CERTIFICATE OF APPROPRIATENESS

Property: 1317 Rutland, LT 13, and TR(sic) 14A Blk 174, Houston Heights (Per HCAD)

Proposal: Alteration – Addition
For Elevator

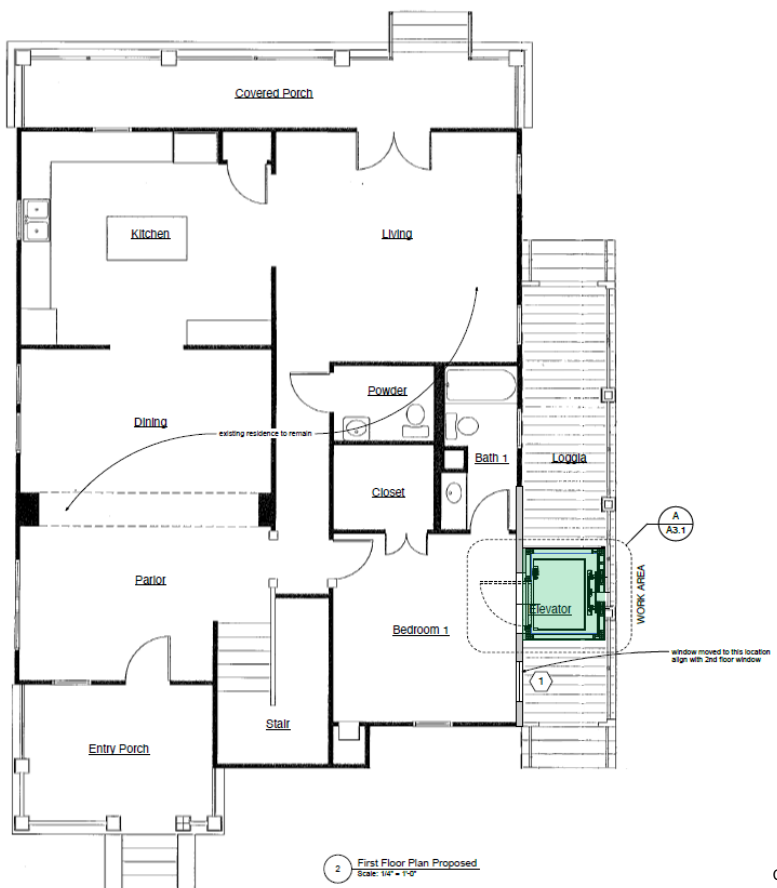
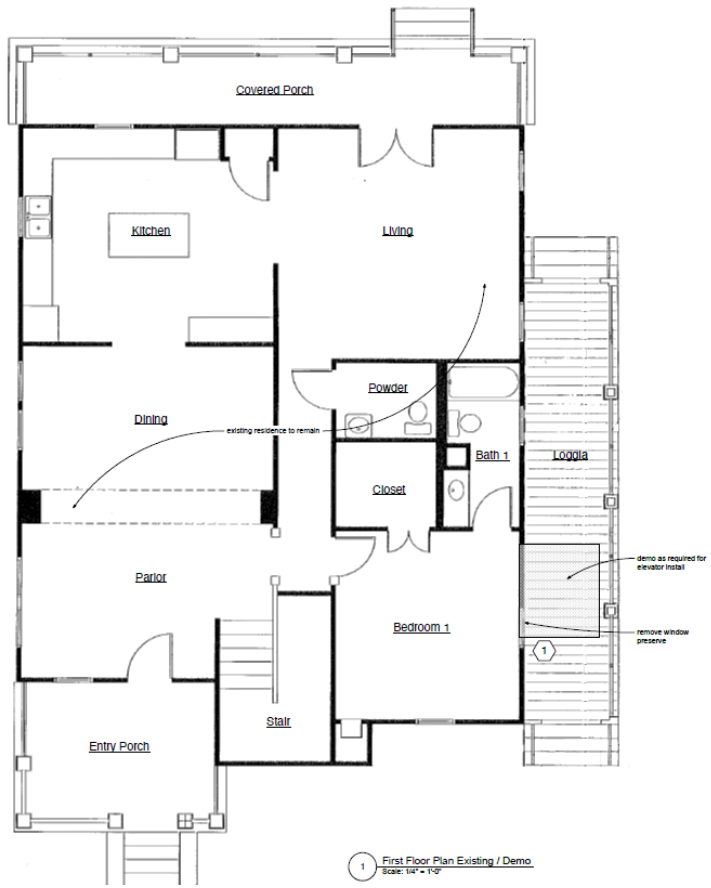
House is 2,368 SF; 1,250 Detached -528 SF + 722 + 2,368 = 3,090. Appears over FAR.
Recommend Approval due to accessibility.

Recommendation: Approval
